Town of Arlington

**FINAL
REPORT**

**ADA Self-Evaluation
(as basis for Transition Plan)**

Prepared by
Institute for Human Centered Design
December 15, 2014

Portable Toilet

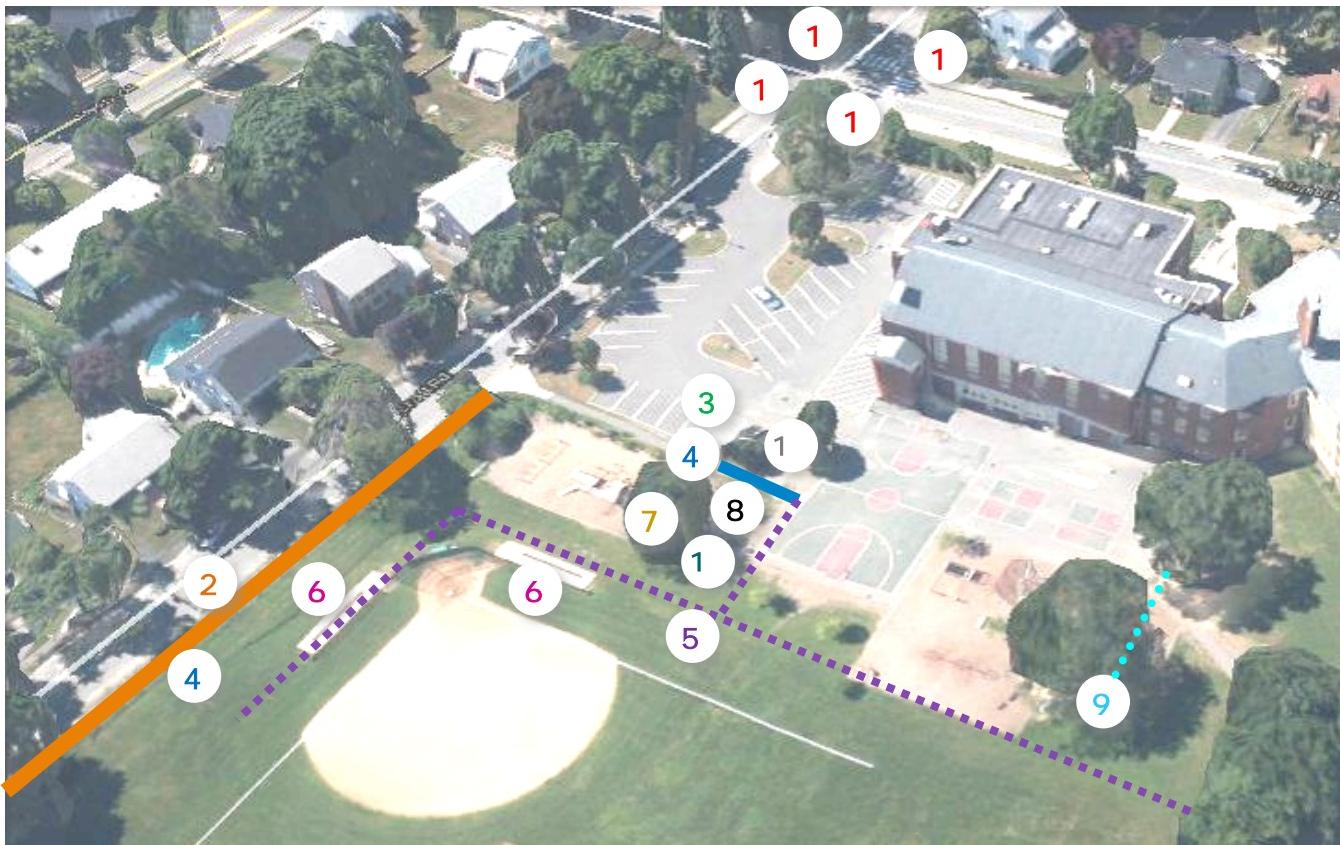
Relocate the portable toilet along the existing walkway or extend the asphalt walkway to it (about 2 feet).

Play Areas

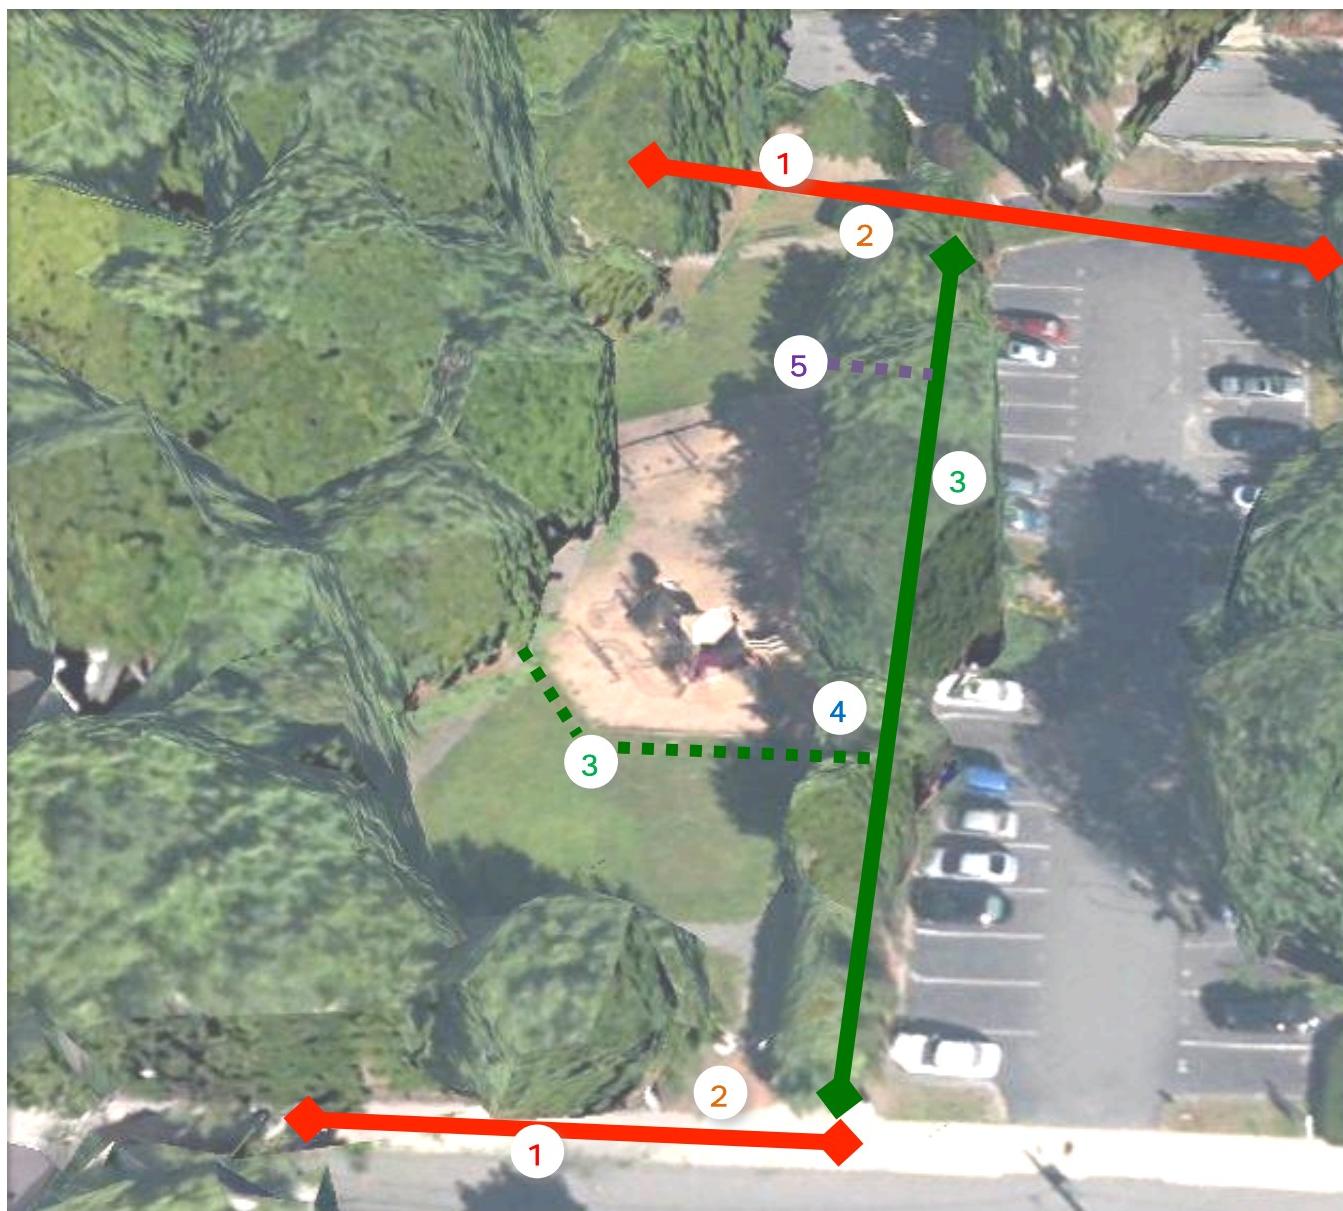
Remove a portion of curb along the perimeter of the playground and replenish or replace the ground surface so that it is flush with the adjacent walkway.

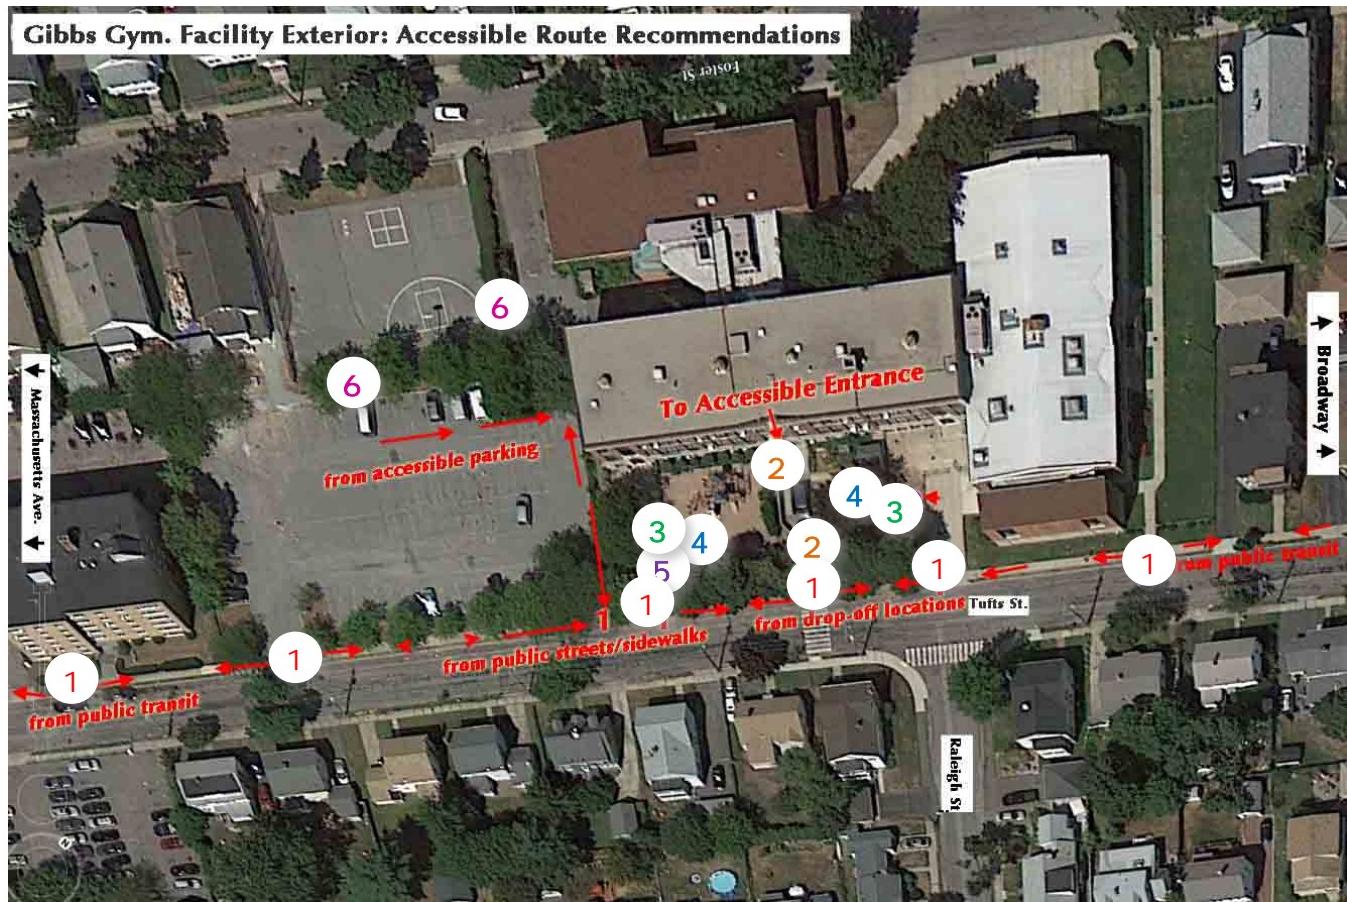
- Replace the faucets of at least one lavatory with ADA-compliant fixtures;
- Protect the plumbing underneath of at least one of the lavatories in each toilet room;
- Lower at least one mirror above a lavatory so that its reflective surface is no higher than 40" above the floor;
- Lower paper dispensers so that their controls are no higher than 48" above the floor;
- Replace grab bars with ADA-compliant accessories inside the accessible toilet stalls;
- Install audible and visible fire alarms.

Bulletin Board

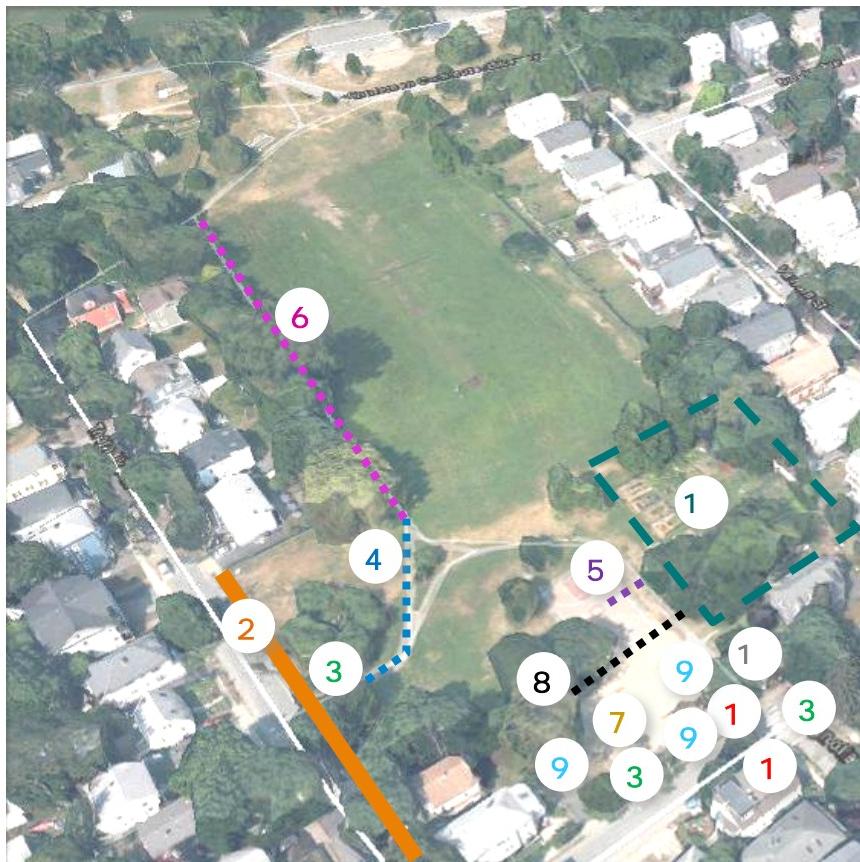
Although not a requirement under the ADA, consider extending the asphalt walkway to the bulletin board (about 5 feet).

Drinking Fountain

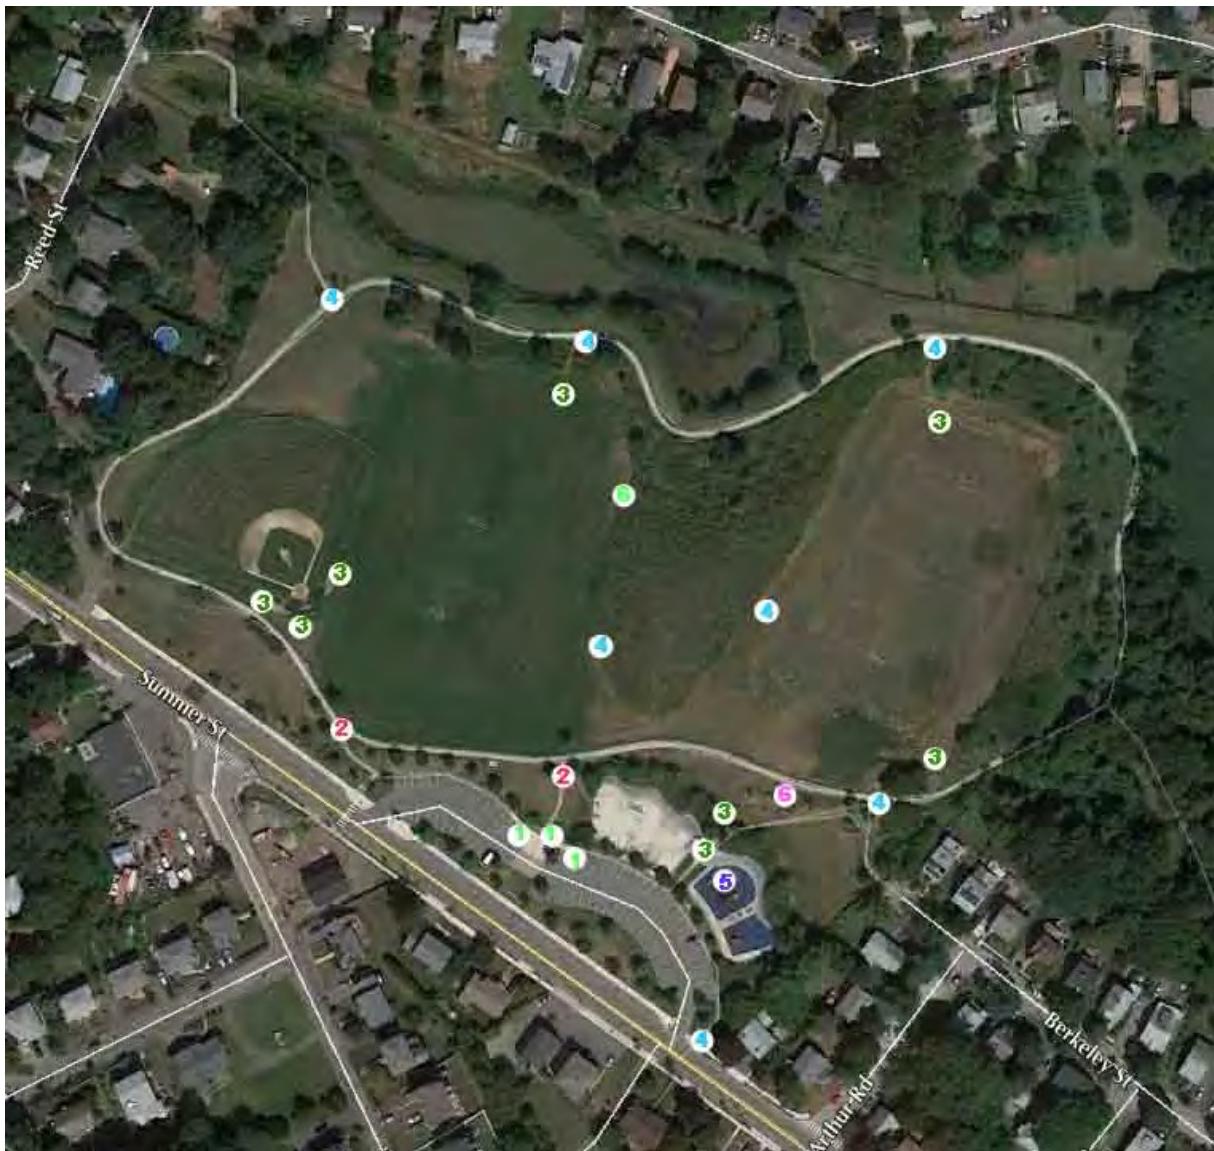
If drinking fountain will be maintained in working order, ensure that forward approach to fountain include a clear ground space that does not overlap with other uses, such as reading sign and integrated seating location.

Play Areas

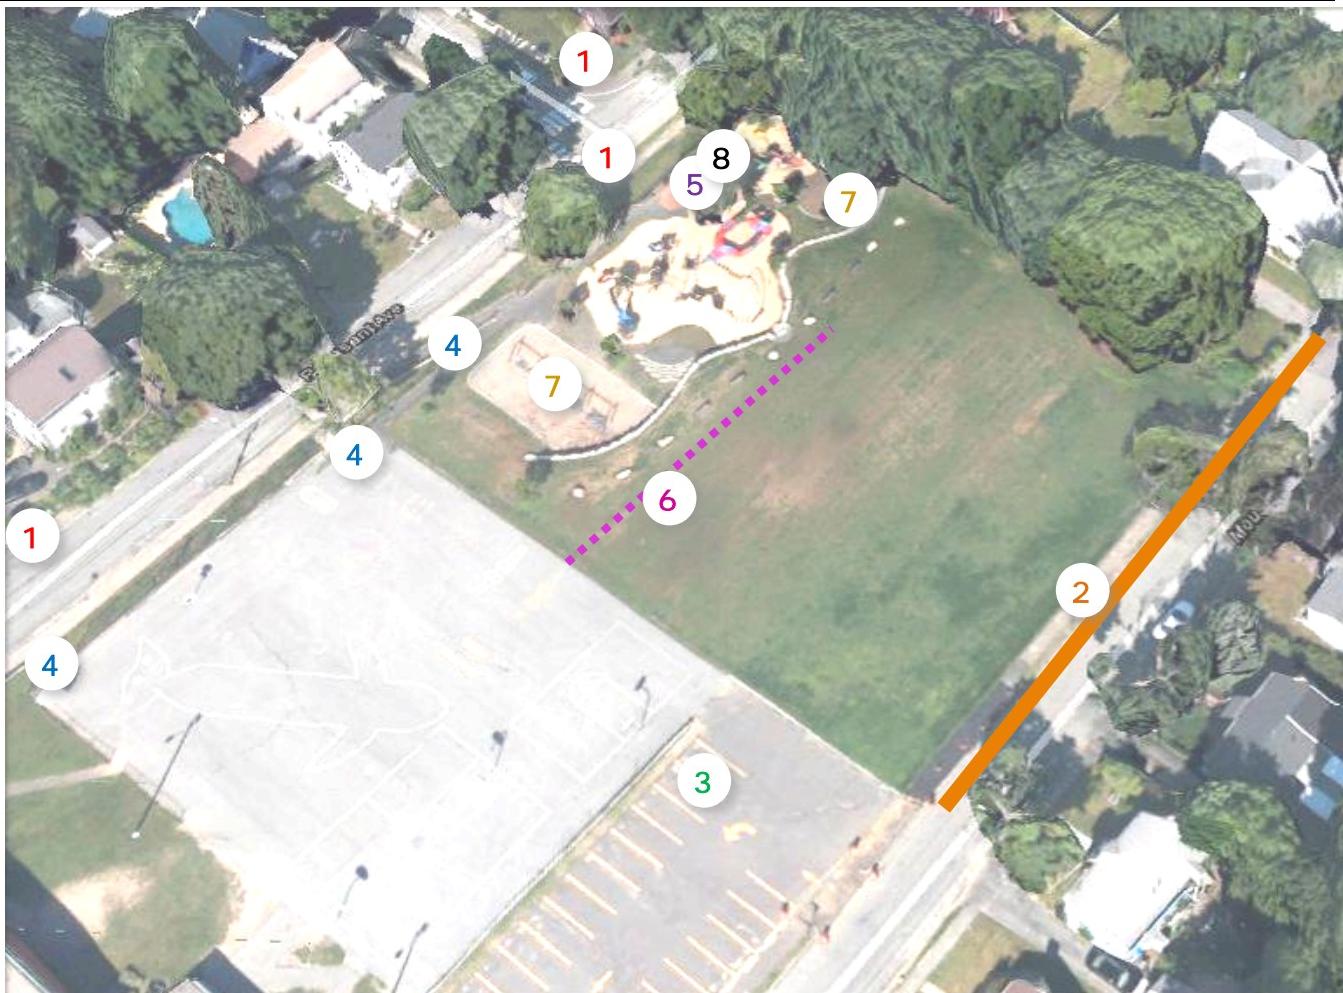
Replenish or replace the ground surfaces in both swingset areas so that they are flush with the adjacent walkway.

Drinking Fountains

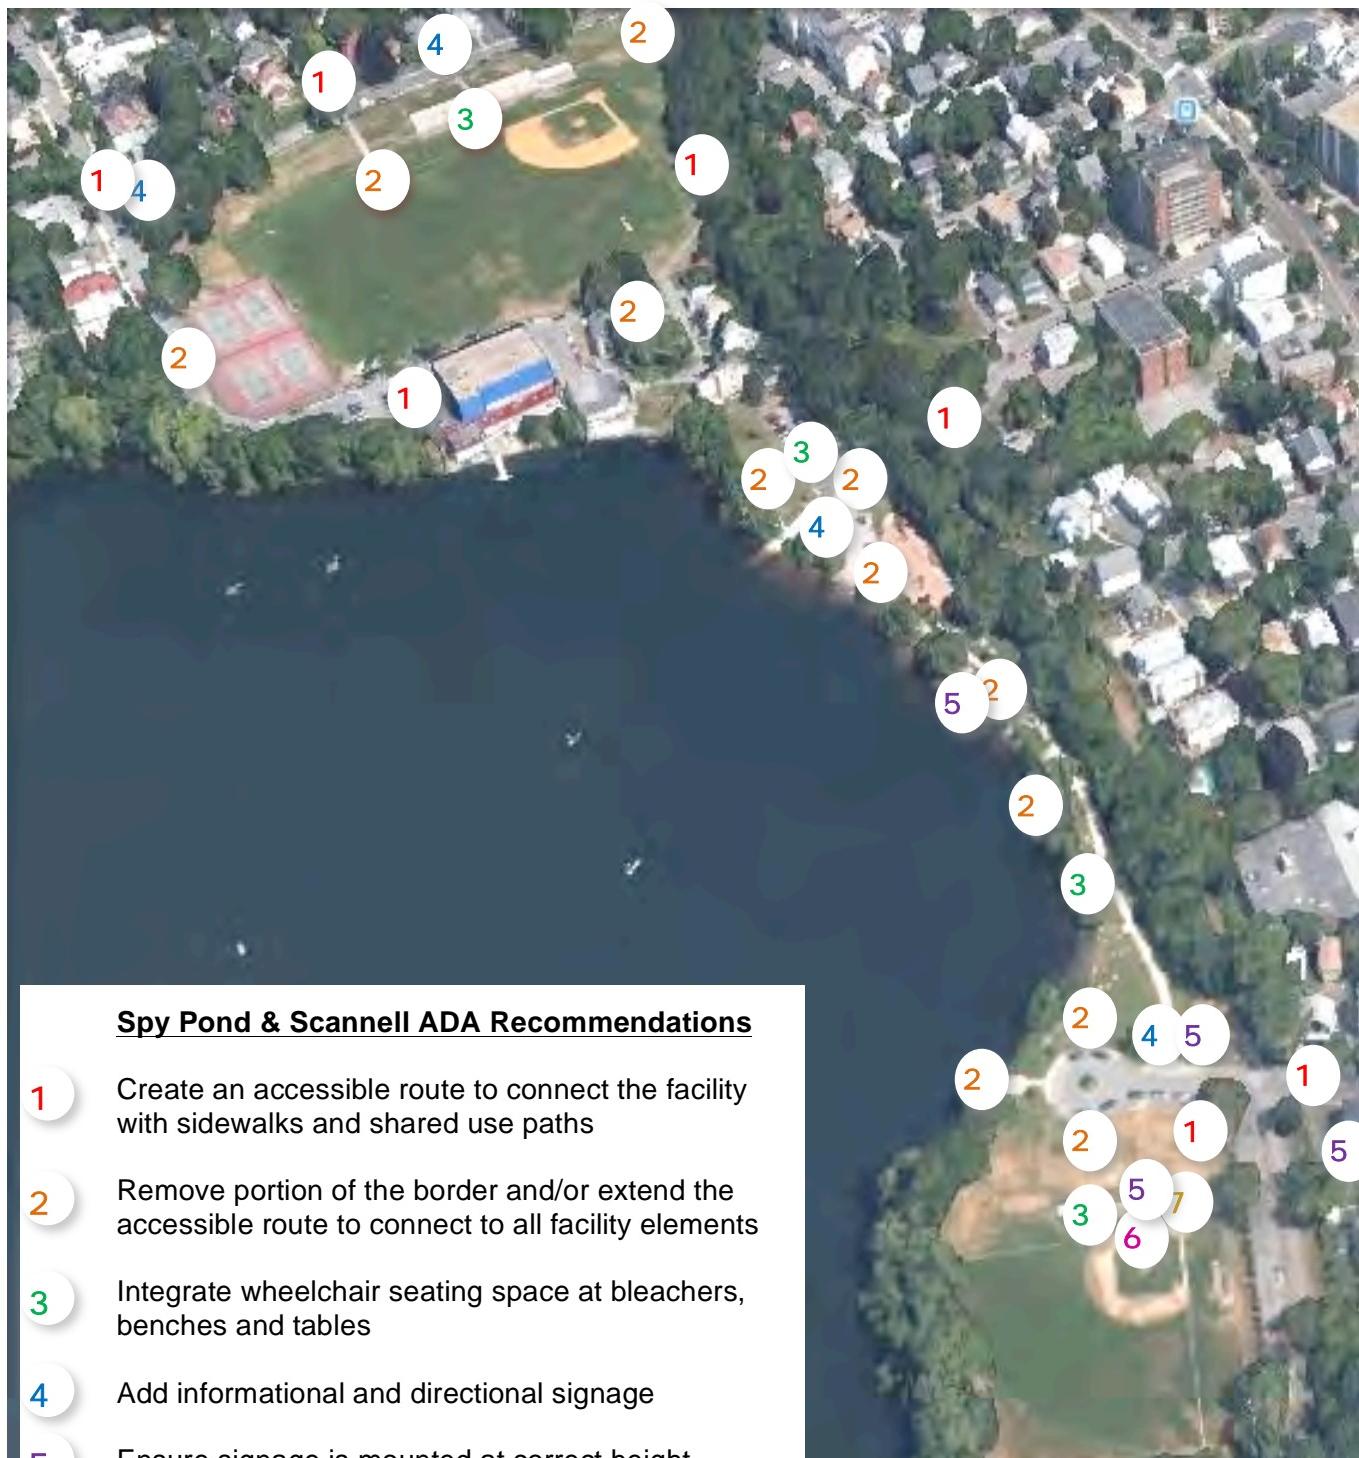
Reconstruct anchoring concrete panels to provide a clear approach and use space of at least 30 in. width and 48 in. length at both north and south fountains. 48 in. width may overlap with a maximum of 19 in. underneath fountains. This clear approach space should adjoin at least one accessible route or walkway. Fountains should be oriented for forward, not parallel, approach.

Bulletin Board

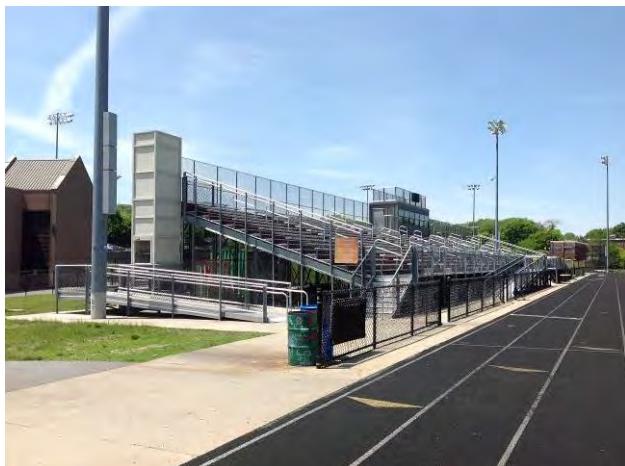
Although not a requirement under the ADA, consider extending the asphalt walkway to the bulletin board (about 2 feet).
